TEXAS COMMISSION ON ENVIRONMENTAL QUALITY

NAME OF PROJECT: Hunter Quarry II; Located approximately 0.1 miles northeast of the intersection of FM1102 and FM 2439; Hunter, Texas

TYPE OF PLAN: Request for Approval of a Water Pollution Abatement Plan (WPAP); 30 Texas Administrative Code (TAC) Chapter 213 Edwards Aquifer

Attn: Ms. Monica Reyes
Subject: Proposed Water Pollution Abatement Plan (WPAP) – Response to Questions
Hunter Quarry II – EAPP ID No. 13-13072901, RN102380250
Colorado Materials, Ltd. – CN600522452

WPA SITE MAP
HUNTER QUARRY II
COLORADO MATERIALS,
COMAL COUNTY, TX

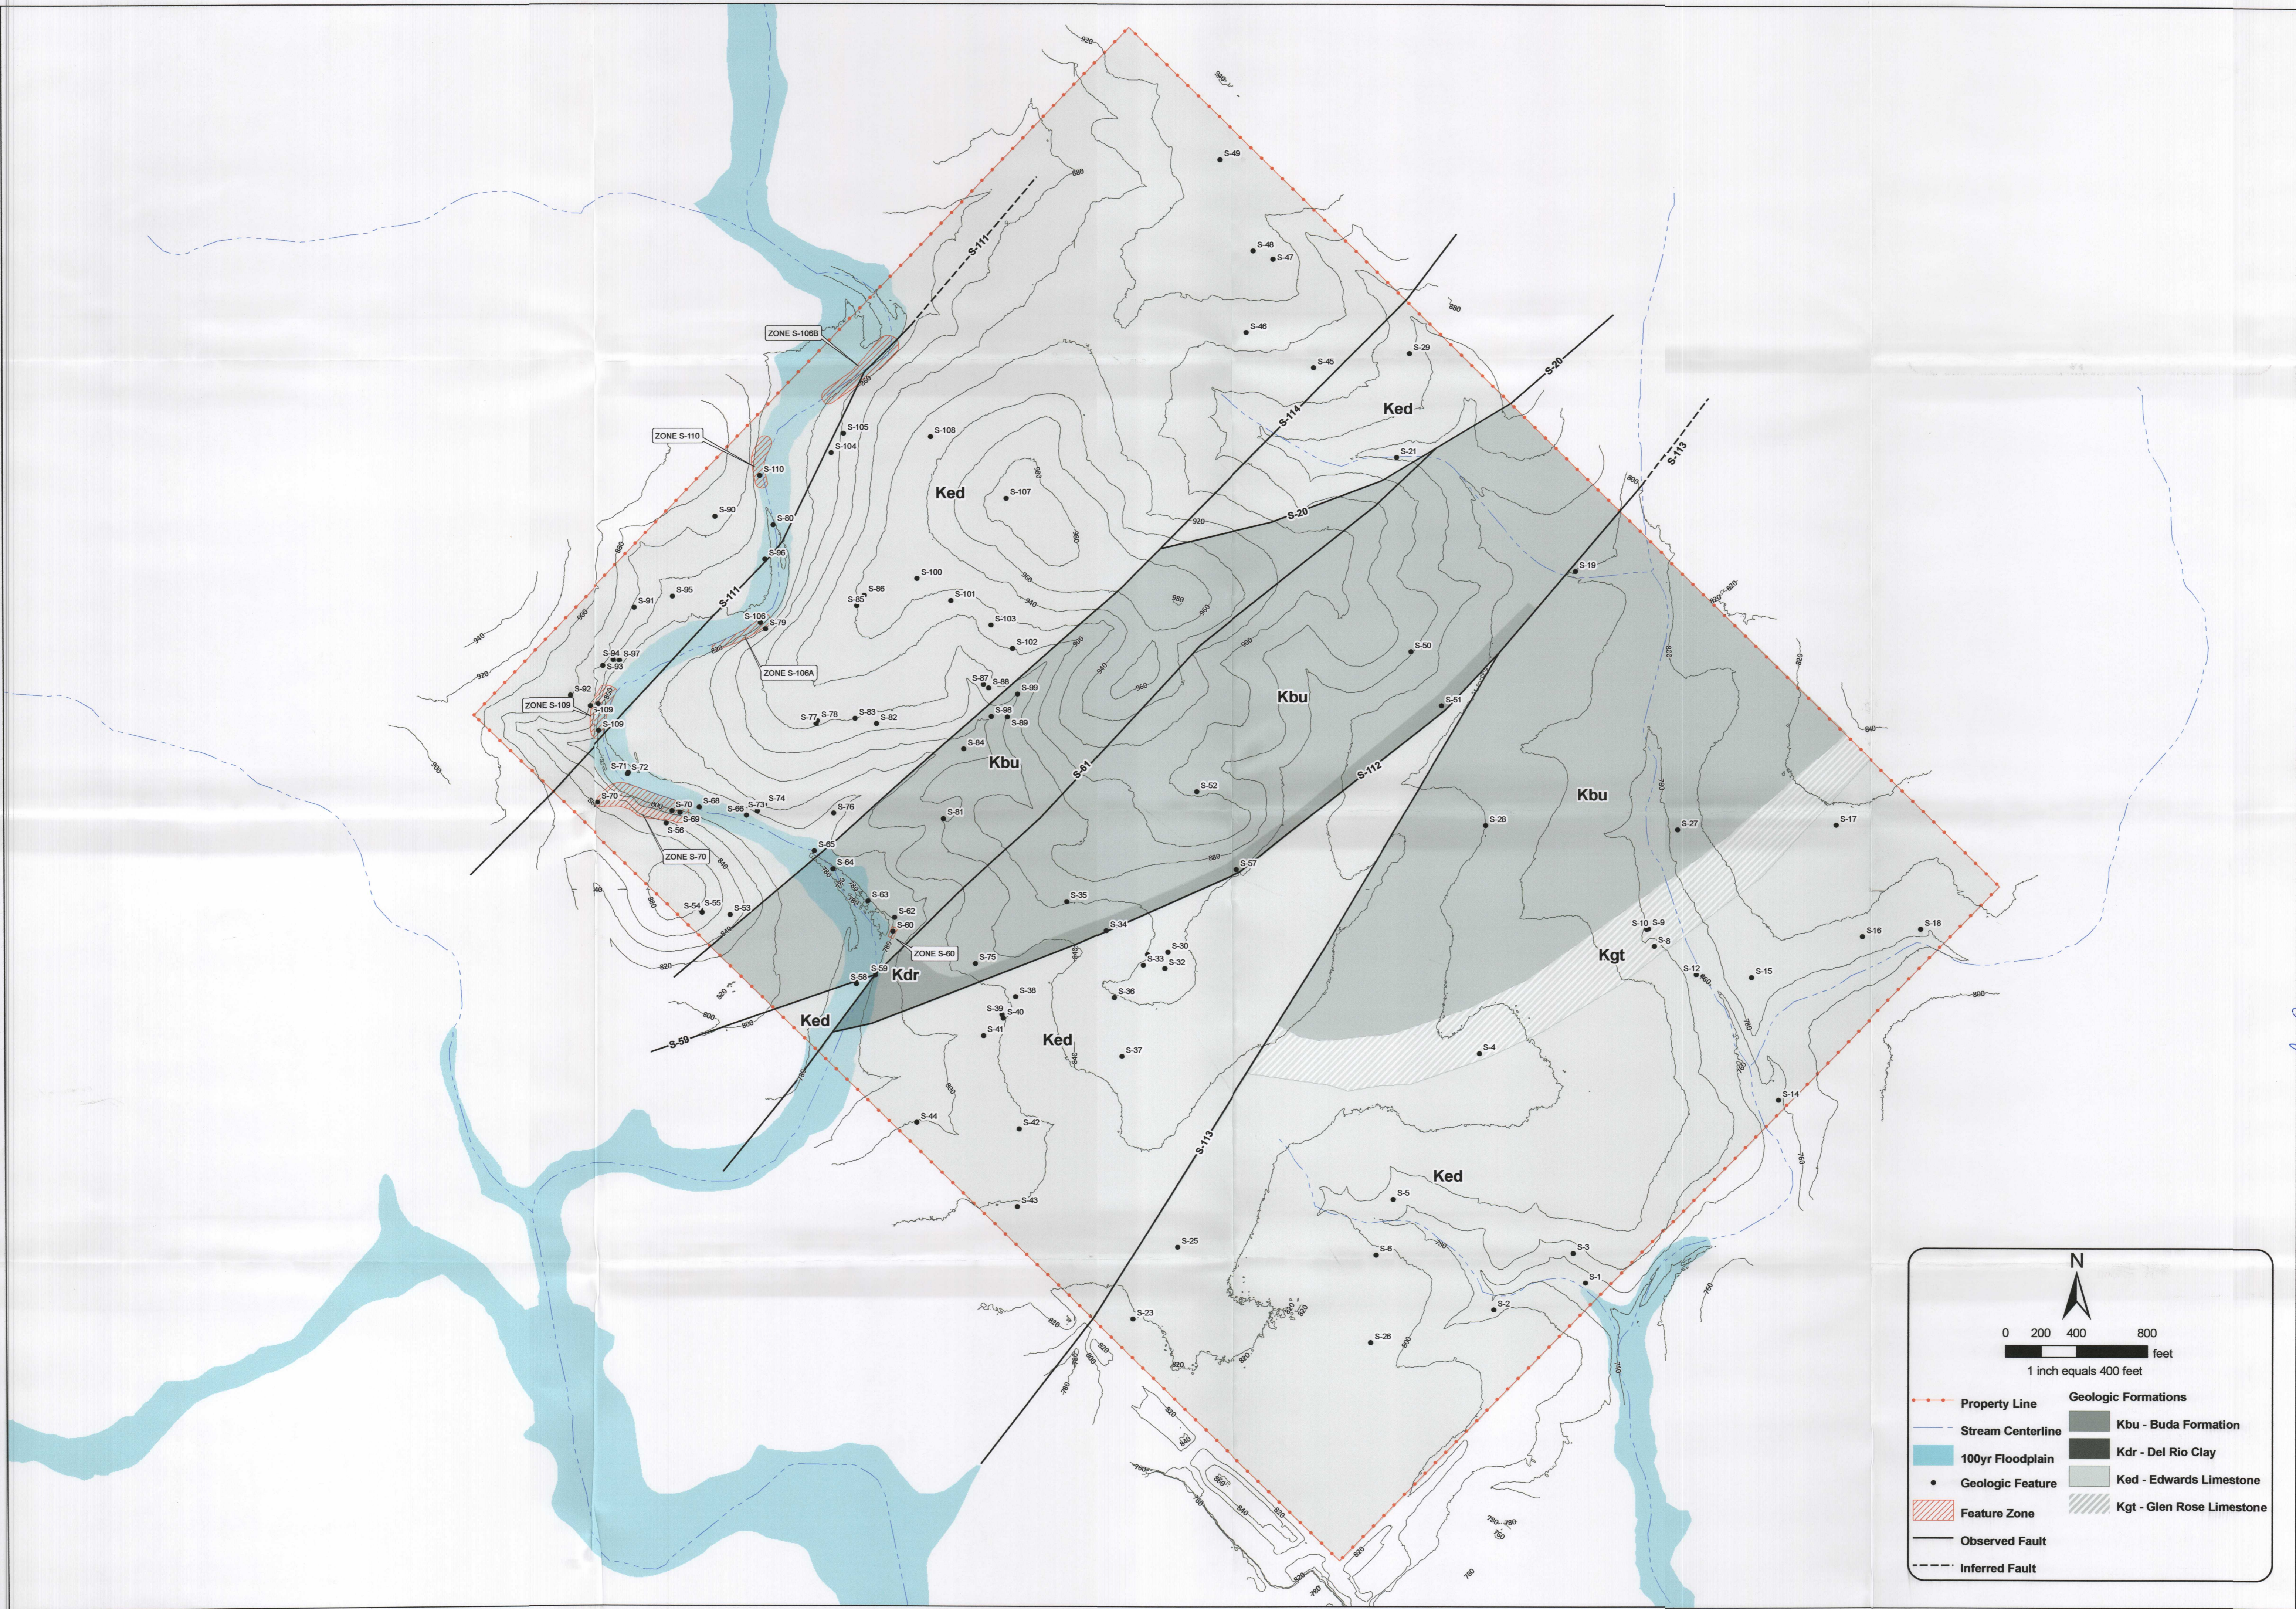
Please show 25' buffer around Bullhead Hollow.

1. Please show 25' buffer around Bullhead Hollow.

Response: Please see the attached revised WPAP Site Plan which has been revised to include the 25' buffer around Bullhead Hollow.

REV	DESCRIPTION	BY	DATE
△	ADD ZONE S-60	JUS	10/07/2013
△	ADD TEMPORARY 25' BUFFER	JUS	10/07/2013

GEOLOGIC ASSESSMENT MAP
HUNTER QUARRY II
COLORADO MATERIALS, LTD
COMAL COUNTY, TX

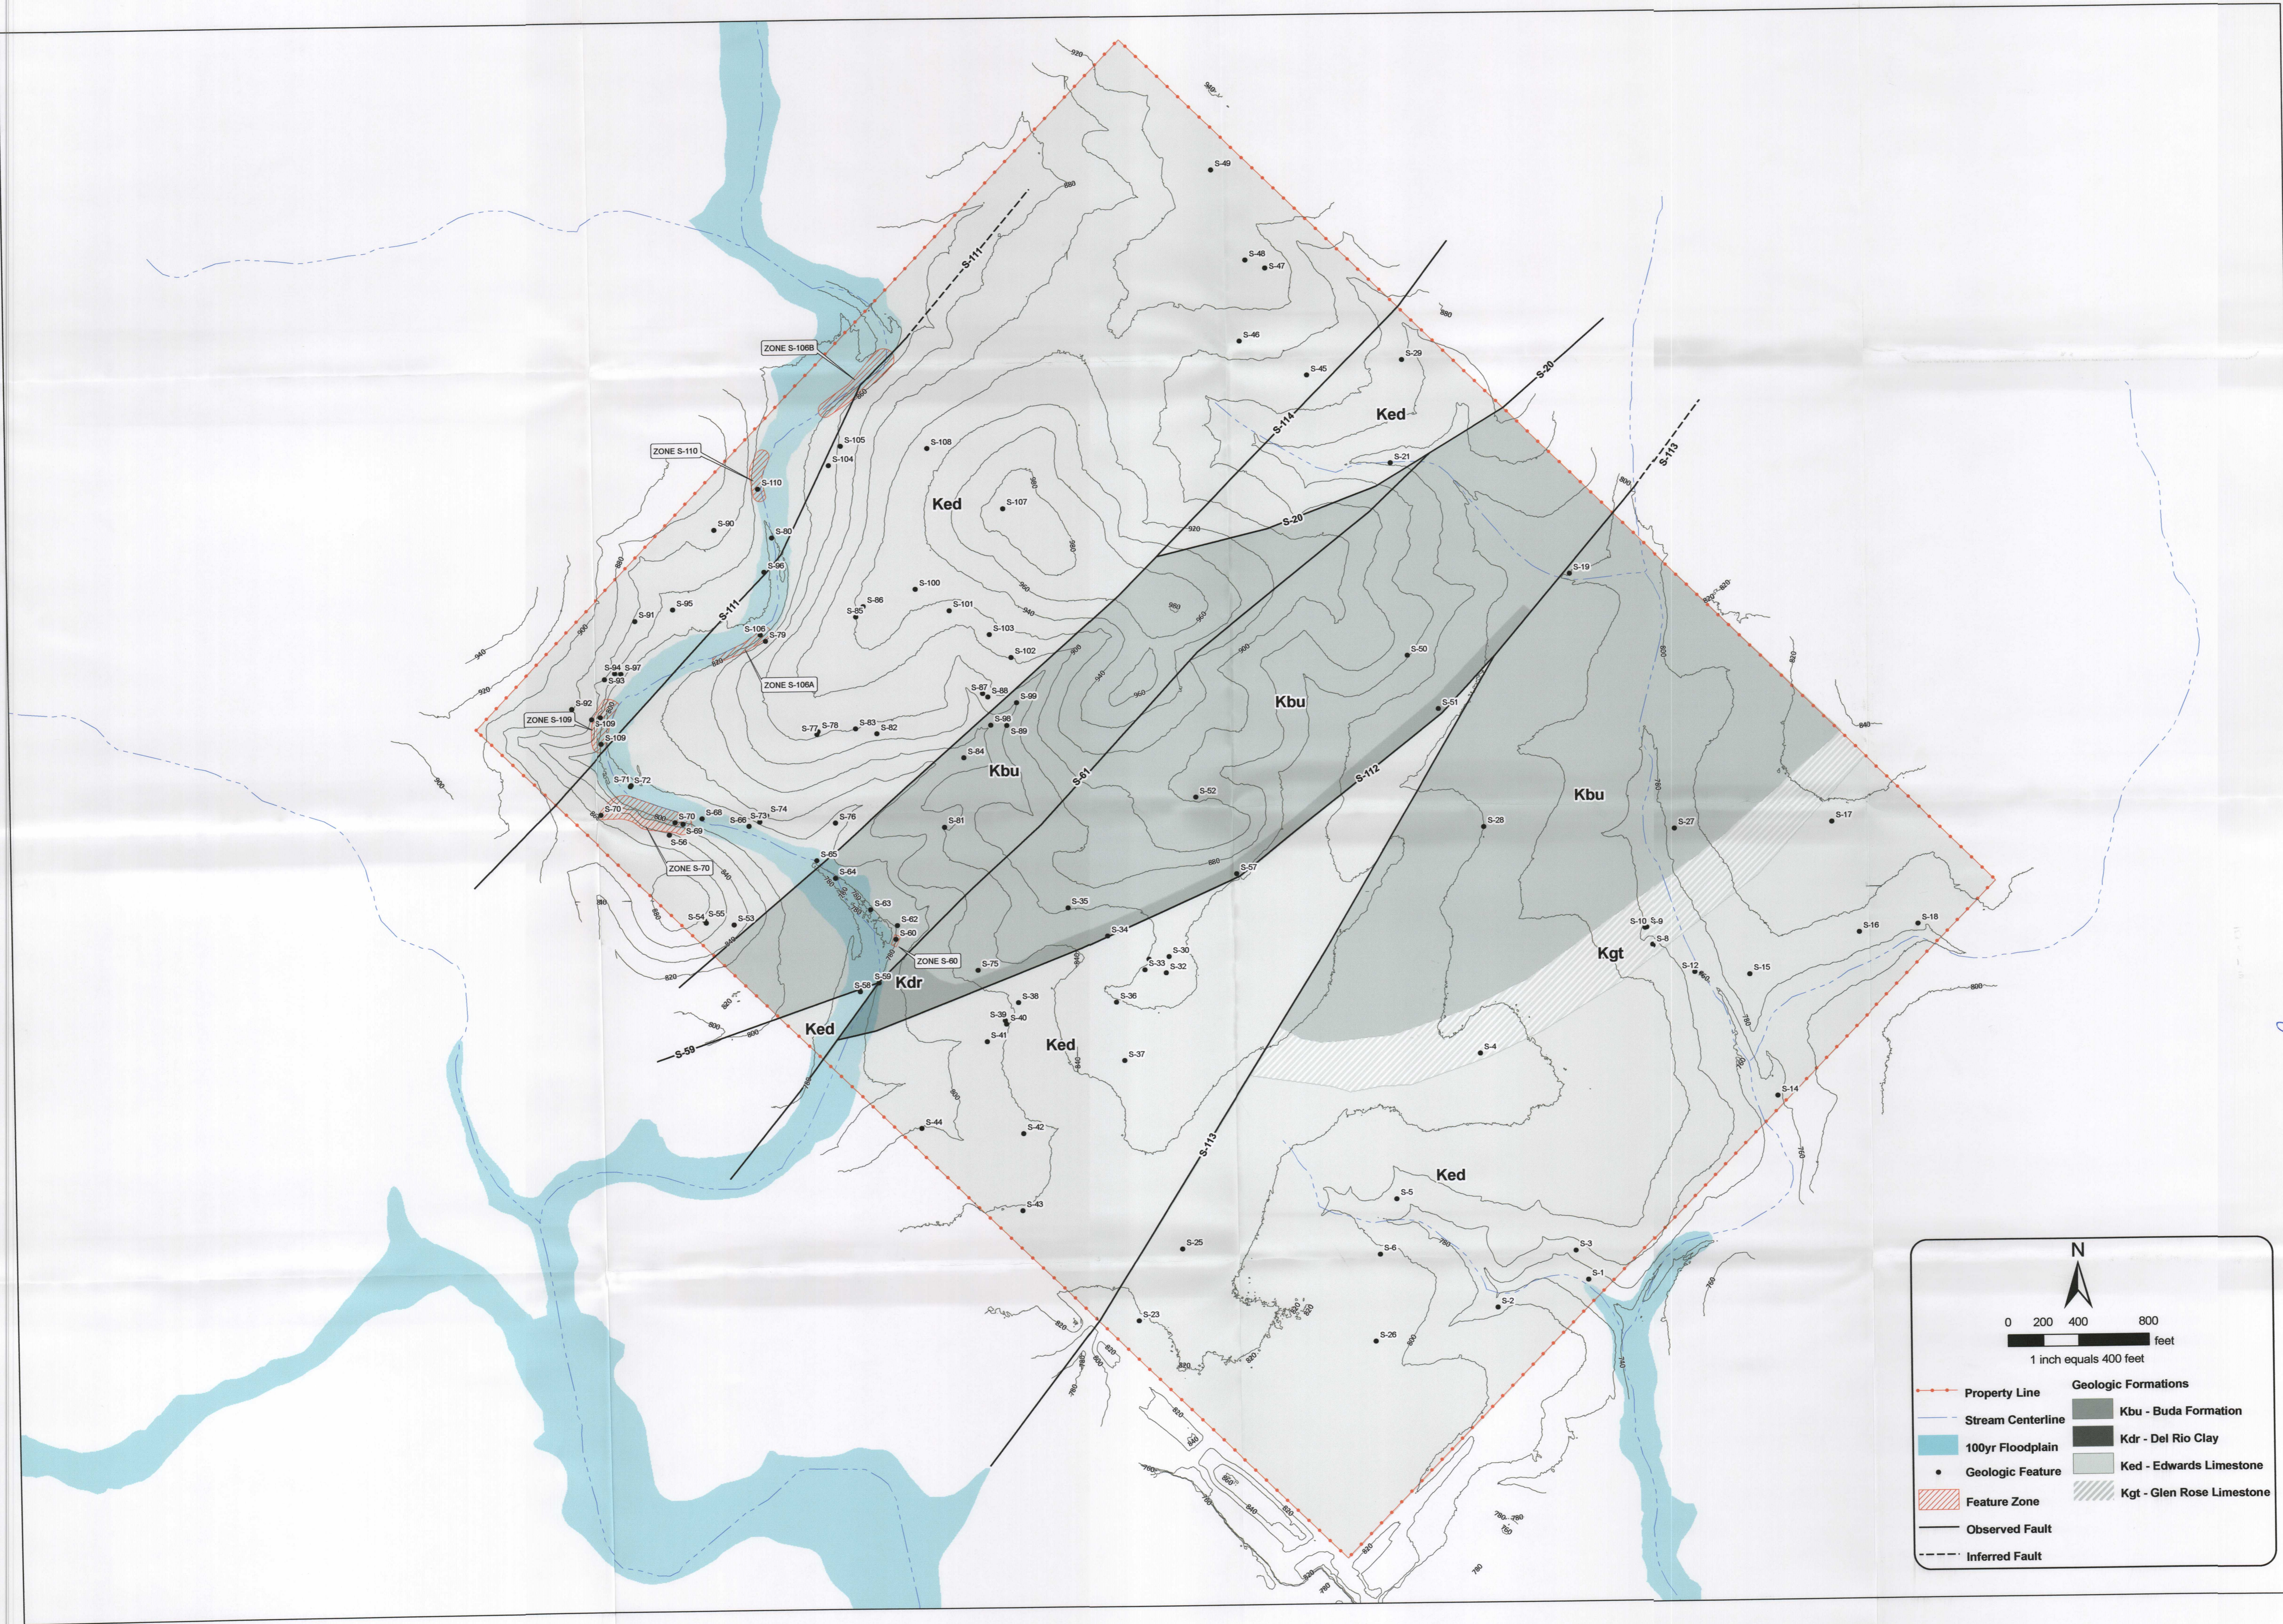
Please show S-60 as feature zone.

1. Please show S-60 as feature zone.

Response: Please see the attached revised Geologic Assessment Map and WPAP Site Plan which have been revised to show S-60 as a Feature Zone. Feature Zone S-60 is 45' by 20' and therefore may be difficult to see at the map scale.

REV	DESCRIPTION	BY	DATE
1	ADD ZONE S-80	JUS	10/04/2013
